Access Compliance Report

Public Rights-of-Way

Intersection ID: 21548	Main Street: OLD_PROVIDENCE_RD	Cross Street: PROVIDENCE_RD	Location: S
ADA ID: F638790E638B	Ramp Type: IslandPerp	Initial Pass/Fail: Pass	Overall Compliance: No
Severity Score: 0.25			
Codes/Mitigation Info/Possible Solution		Field Measurements/Component Compliance

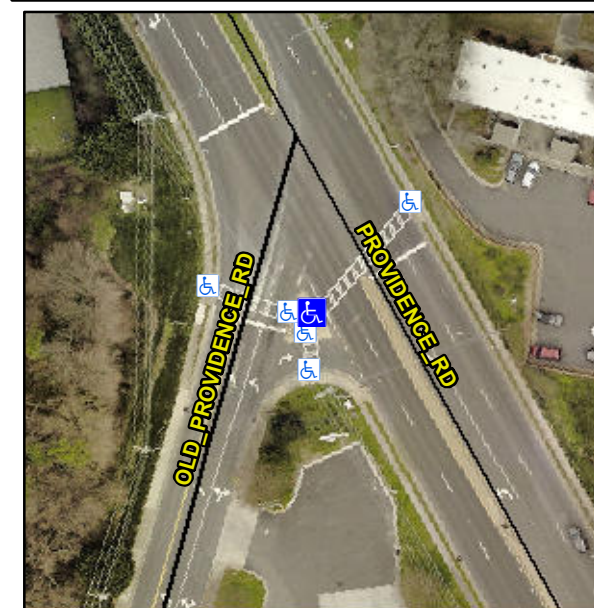
Not Found, R304.5.3, R304.2.2-Perp, R304.3.2-Para, R305.2

Compliance	Description	Data	Compliance	Description	Data
N/A	Ramp Length (in)	48.0	Yes	Ramp Slope (%)	5.6
Yes	Ramp Width (in)	48.0	No	Ramp XSlope (%)	2.3
N/A	Flare Type LT	Sloped	N/A	Flare Type RT	N/A
N/A	Flare Slope LT (%)	19.4	N/A	Flare Slope RT (%)	17.4
N/A	Flare Traversable LT?	No	N/A	Flare Traversable RT?	No
Yes	Landing Length (in)	48.0	Yes	DWS Provided?	Yes
Yes	Landing Width (in)	48.0	Yes	DWS Contrast?	Yes
No	Landing Slope (%)	2.1	Yes	DWS Length (in)	24.0
Yes	Landing X Slope (%)	0.6	Yes	DWS Full Width?	Yes
N/A	Landing Curb? (Y/N)	No	No	DWS Offset (in)	3.0
N/A	Shared Landing?	Yes			
Yes	Gutter Ponding?	No	Yes	Gutter Slope (%)	2.4
Yes	Gutter Lip Ht (in)	0.0	Yes	Gutter X Slope (%)	1.3
N/A	Painted X Walk1?	Yes	N/A	Painted X Walk2?	N/A
	X Walk 1 Direction	To NE		X Walk 2 Direction	N/A
N/A	X Walk 1 Width (in)	78.0	N/A	X Walk 2 Width (in)	N/A
	X Walk 1 Slope (%)	4.8		X Walk 2 Slope (%)	N/A
	X Walk 1 X Slope (%)	1.6		X Walk 2 X Slope (%)	N/A

Yes	Ramp inside XWalk1?	Yes	N/A	Ramp inside XWalk2?	N/A
	Road Slope (%)	N/A	N/A	Clear Space?	Yes
	Road X Slope (%)	N/A	N/A	Clear Space to XWalk (in)	N/A
Yes	Any Obstructions?	No	Yes	Storm Grate/Utility Hazard?	No
	Obstruction Type			Storm Grate/Utility Type	
		N/A			N/A
			Yes	Surface Condition? (G/P)	Good

Remove & Replace Entire Ramp.
